N60087.AR.000846
NAS BRUNSWICK
5090.3a

August 31, 1999

**Re: EPA Supplemental Comments to the Draft 1998 Annual Monitoring Report for Sites 1, 3
and the Eastern Plume, Naval Air Station, Brunswick, Maine**

ATTACHMENT

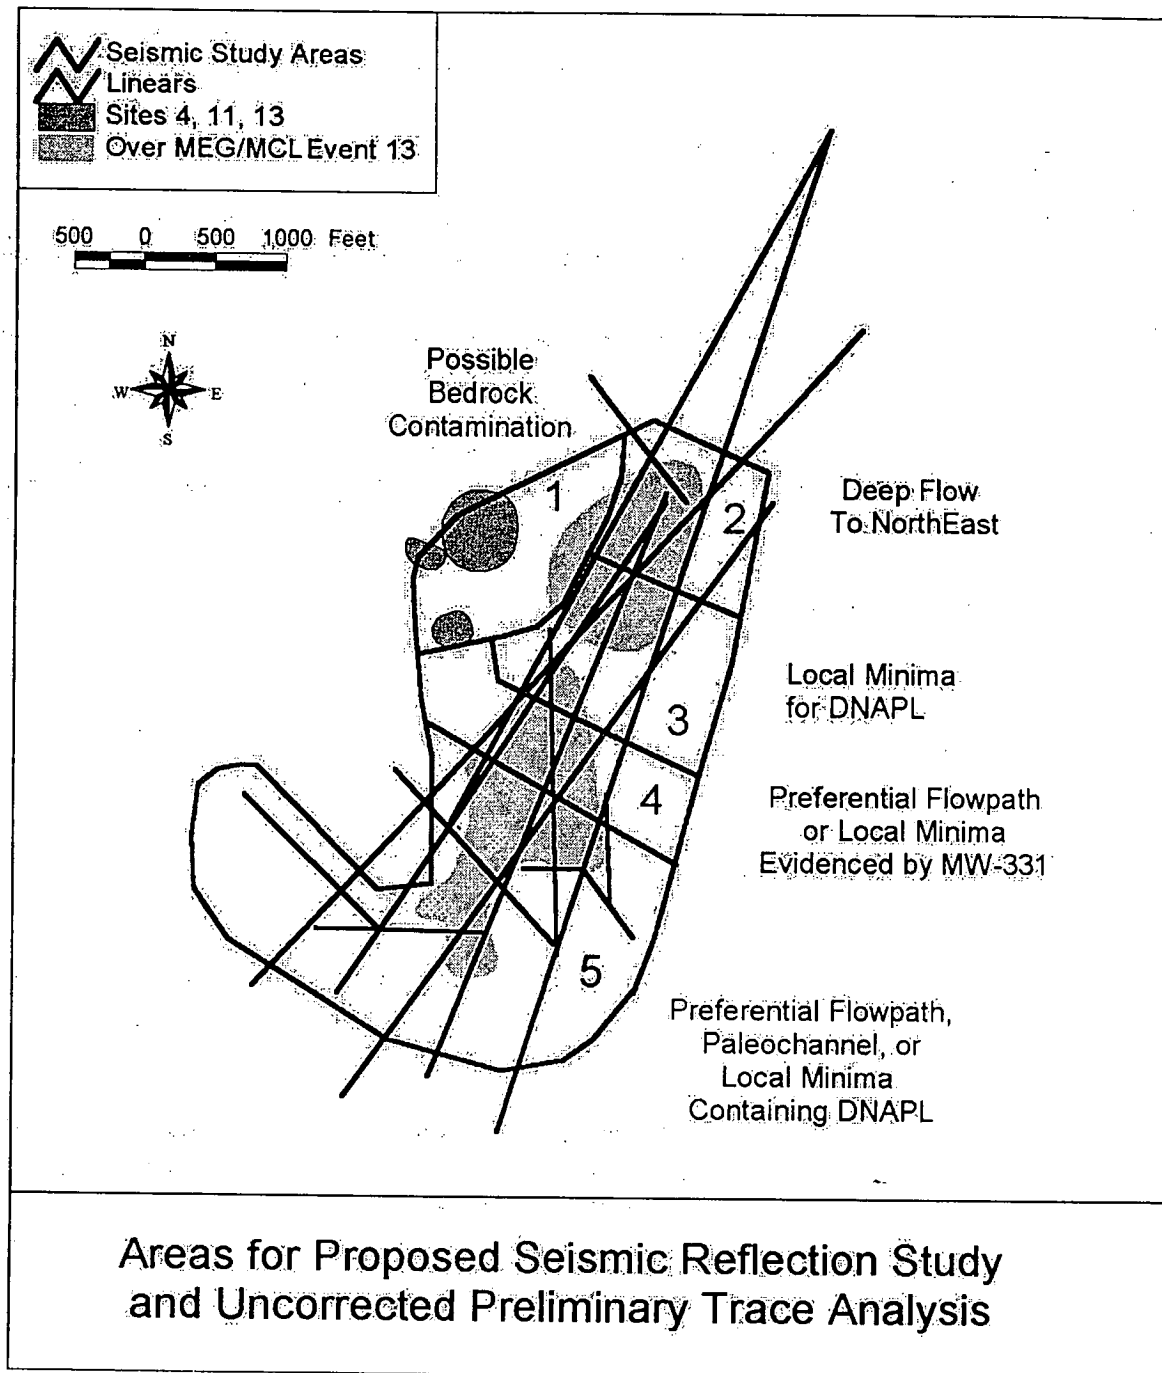
A more complete fracture trace analysis (Figure 1) was performed by identifying linear alignments of topographic sags, surficial drainage, bedrock depressions, top-of-clay depressions and elongate scouring in bedrock on both small and large-scales. Elongate scouring of bedrock was identified as 1) long, narrow submarine trenches, 2) long narrow marine bays, 3) saddles in bedrock-controlled topographic heights, and 4) short, elongate bedrock-controlled ravines and valleys.

The analysis used the surface water, bedrock, clay isopach and preliminary top-of-clay GIS themes for the Eastern Plume. These and other themes have apparent distortion relative to be available raster image of the USGS 1:24000 topographic map for Brunswick. This impacts the analysis, since the linears were defined using the distorted GIS themes and the rectified topographic map. The theme distortion varies by location, but typically amounts to a 100-150 ft. shift to the West in the areas of greatest interest. In spite of this, the uncorrected trace analysis presented in Figure 1 is sufficiently accurate for general planning purposes.

The further trace analysis suggests that the Merriconeag Stream valley is located at the convergence area of a radial pattern of multiple linears, with a general NE-SW orientation. There is some evidence, primarily hydrologic and topographic, that suggests that several sub-parallel NW-SE or W-E linears cross the valley as well. If this is true, then the Merriconeag Stream valley may have significant sub-vertical, primary and secondary fracture interconnection, reducing the possibility that bedrock contamination downgradient of Site 11 may flow significantly to the Southwest, along a fracture path. However, proof of high bedrock interconnectivity would not impact the possibility of an overburden preferential flowpath to the Southwest.

Figure 1 demonstrates that five areas of the Eastern Plume have separate investigative needs.

- Area 1 needs to be investigated to determine the spatial extent of the near-source No-Clay zone and the possibility of bedrock contamination (Figure 3).
- Area 2 needs to be investigated to more clearly determine reasons for the deep flow Northeast of the source area, for the possible role of the apparent underlying convergence of linears, and for the possible existence of DNAPLs.
- Area 3 encompasses a local minimum in the top-of-clay surface that needs to be defined spatially, and tested for the existence of DNAPLs.
- Area 4 encompasses recently developed well MW-331, which is located in an apparent bedrock depression, and has registered electrical conductivity values 5-10 times that of other Eastern Plume wells. The spatial extents of this bedrock depression, and possible

paleochannels or preferential flowpaths need to be defined, followed with testing for DNAPLs.

- Area 5, at the southern termination of the plume needs investigation to explain the apparent lack of progress of the plume over time, and to assess whether the entire plume is being captured by extraction efforts. Possible explanations for the plume behavior include flow to surface waters (currently under investigation), an undetected preferential groundwater flowpath or paleochannel in the overburden to the Southwest, and DNAPL pooling or flow in the overburden. These explanations for plume behavior have varying probabilities, but none can be ruled out given current knowledge.

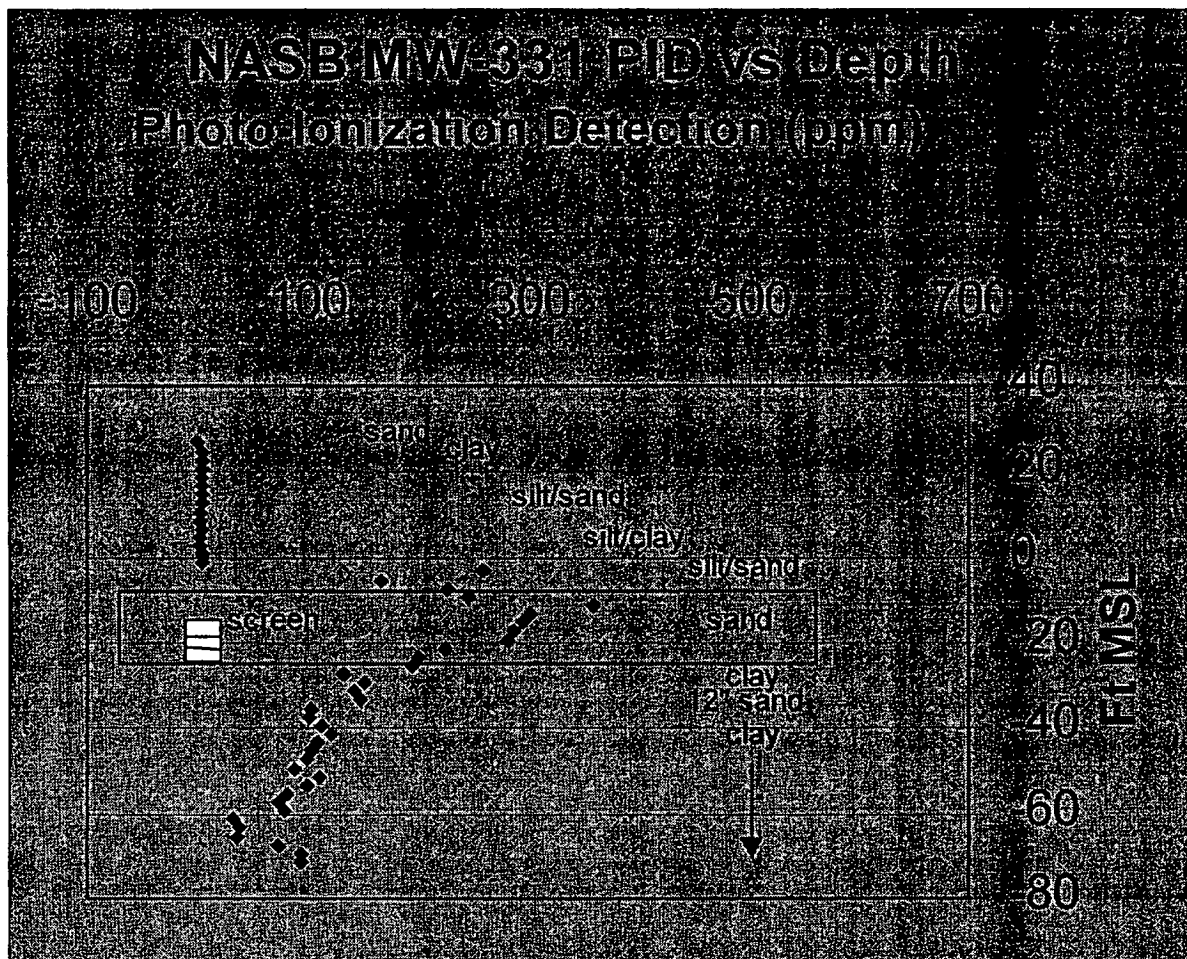
The Record of Decision for the Eastern Plume states that the primary contaminants at Site 11 are DNAPLs, and consequently, residual contaminants may still exist at depth (U.S. Navy, 1998). Although other mechanisms exist and may be more likely, the apparent penetration of contamination into the clays

at MW-331 (Figure 2), the plume flow to the Northeast, and the stalling of the southern leading-edge of the plume can all be explained by a DNAPL presence. However, DNAPLs were discounted in the remedial investigation on the basis of the industry's 10% of solubility limit guideline, 2D fate modeling and evidence that supported a capillary fringe source theory (U. S. Navy, 1992).
